MECKLENBURG COUNTY HEALTH DEPARTMENT
ENVIRONMENTAL HEALTH DIVISION

APPLICATION FOR PERCOLATION TEST

SITE DISAPPROVAL REPORT
INDIVIDUAL SEPTIC TANK SYSTEM WITH SUBSURFACE, SOIL ABSORPTION, EFFLUENT DISCHARGE

LOCATION OF LOT Karenstone Drive, Lot 12

ACCURATELY DIAGRAM & DIMENSION LOT

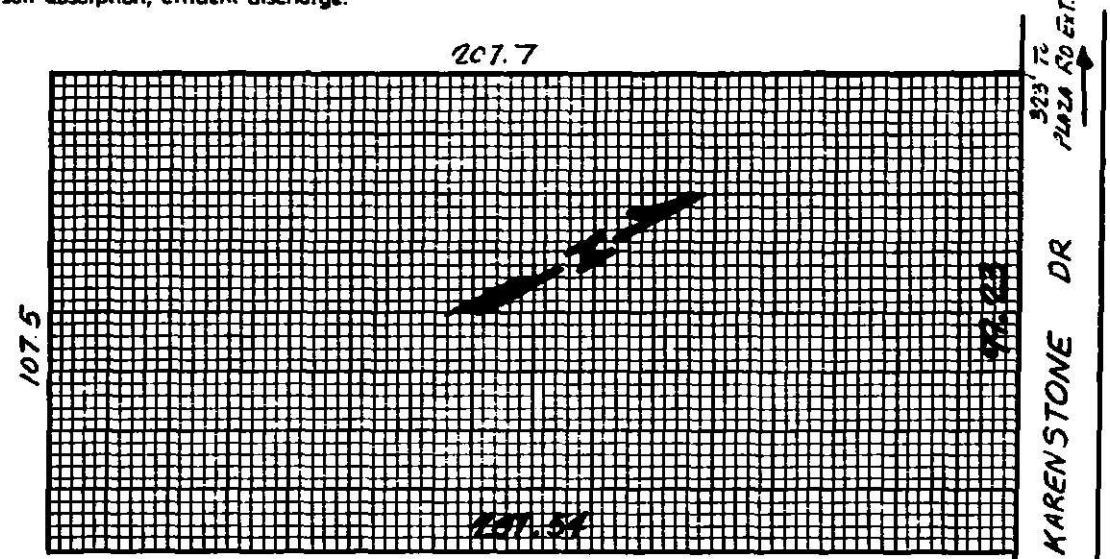
The lot described above has been disapproved for the installation of an individual septic tank system with subsurface, soil absorption, effluent discharge due to the following:

FAILURE TO PASS PERCOLATION TEST (60 minutes per inch or less)

Test No.	Date of Test	Percolation Rate
X	1.	11-16-73	125 min/in
____	2.	_____	_____ min/in
____	3.	_____	_____ min/in
